**GREG BEST
CONSULTING, INC.**

SUPPLEMENTAL ENGINEERING EXHIBIT

This document supports the proposed modification to the construction permit granted to the licensee of KRSF with file number BPED-20160317ABN.

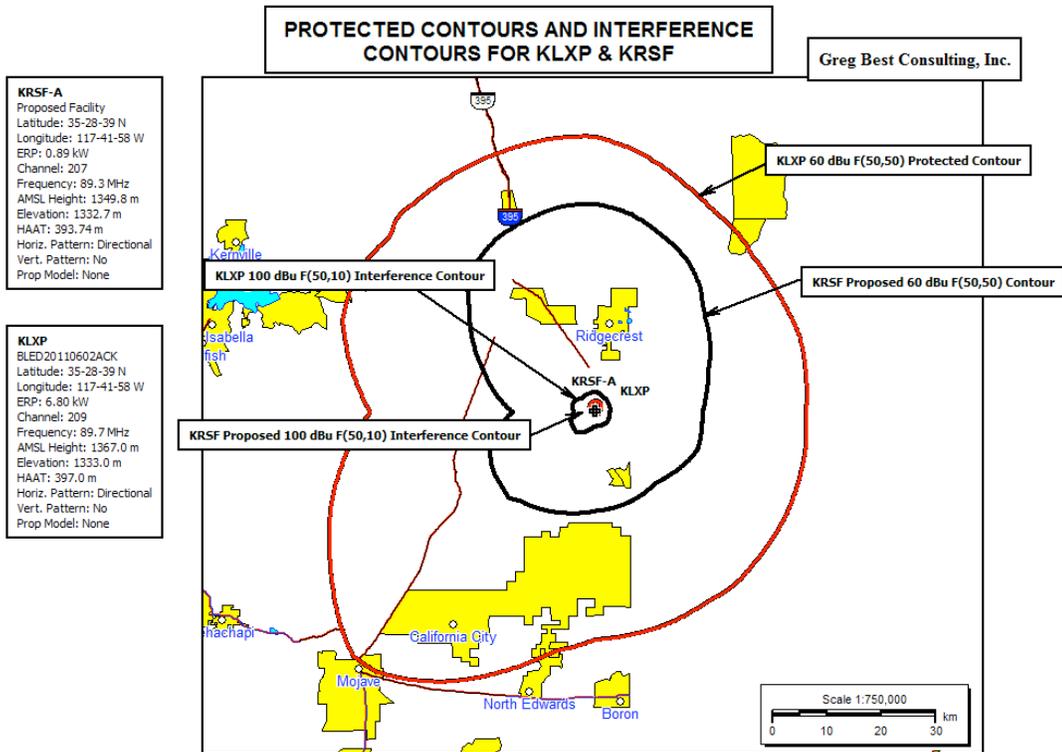
The only exhibit that changes from the previous application is the contour overlap diagram with KLXP and the actual amount of overlap in terms of percentage of land area. The change has no substantive impact on the waiver circumstances. Since the ERP is reduced the amount of contour overlap from KRSF to KLXP is also reduced. Consistent with FCC Rule 73.509(d), the reduction in contour overlap reduces the potential interference. The revised contour overlap with KLXP is attached. Other engineering data relative to the antenna pattern change is contained in the application engineering sections.

Contour overlap of KRSF 100 dBu F(50,10) & KLXP 60 dBu F(50,50) = 4.2 sq km
 Contour Area of KLXP 60 dBu F(50,50) = 6766
 Contour Area Overlap = 0.06% (This amount is a reduction from the existing CP)

Contour overlap of KLXP 100 dBu F(50,10) to KRSF 60 dBu F(50,50) = 39.2 sq km
 Contour Area of KRSF 60 dBu F(50,50) = 1991 sq km
 Contour Area Overlap = 1.97 %
